# Access Compliance Report

## Public Rights-of-Way (Curb Ramps)

Intersection ID: 50338	Main Street: HERMISTON_ST	Cross Street: CASTLECOVE_RD	Location: NW
ADA ID: DBE5680DA3F8	Ramp Type: Para	Initial Pass/Fail: Fail	Overall Compliance: No
		Severity Score: 12.5

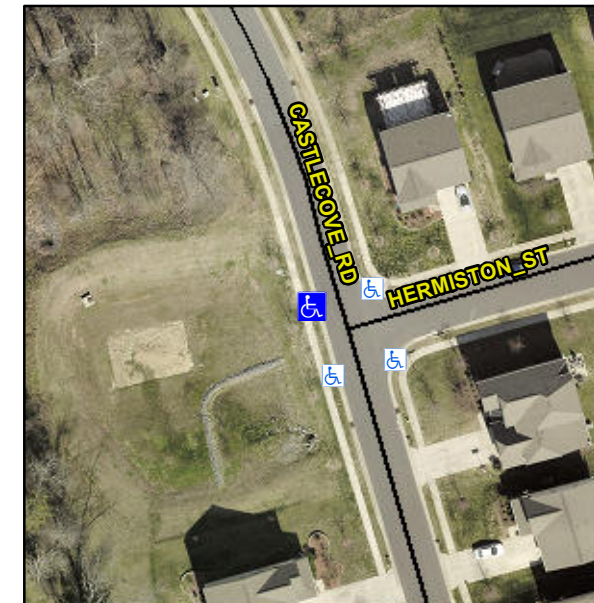
**R304.3.2**

Compliance	Description	Data	Compliance	Description	Data
N/A	Ramp Length LT (in)	42.5	N/A	Ramp Length RT (in)	39.0
Yes	Ramp Width LT (in)	96.0	Yes	Ramp Width RT (in)	96.0
No	Ramp Slope LT (%)	10.3	Yes	Ramp Slope RT (%)	7.0
Yes	Ramp XSlope LT (%)	1.0	Yes	Ramp XSlope RT (%)	1.2
N/A	Landing Length (in)	N/A	N/A	DWS Provided?	N/A
N/A	Landing Width (in)	N/A	N/A	DWS Contrast?	N/A
N/A	Landing Slope (%)	N/A	N/A	DWS Length (in)	N/A
N/A	Landing X Slope (%)	N/A	N/A	DWS Full Width?	N/A
N/A	Landing Curb? (Y/N)	N/A	N/A	DWS Offset (in)	N/A
N/A	Shared Landing?	N/A			
N/A	Gutter Ponding?	N/A	N/A	Gutter Slope (%)	N/A
N/A	Gutter Lip Ht (in)	N/A	N/A	Gutter X Slope (%)	N/A
N/A	Painted X Walk1?	No	N/A	Painted X Walk2?	N/A
	X Walk 1 Direction	To NE		X Walk 2 Direction	N/A
N/A	X Walk 1 Width (in)	N/A	N/A	X Walk 2 Width (in)	N/A
	X Walk 1 Slope (%)	2.5		X Walk 2 Slope (%)	N/A
	X Walk 1 X Slope (%)	2.0		X Walk 2 X Slope (%)	N/A
N/A	Ramp inside XWalk1?	N/A	N/A	Ramp inside XWalk2?	N/A

**Remove & Replace Entire Ramp.**
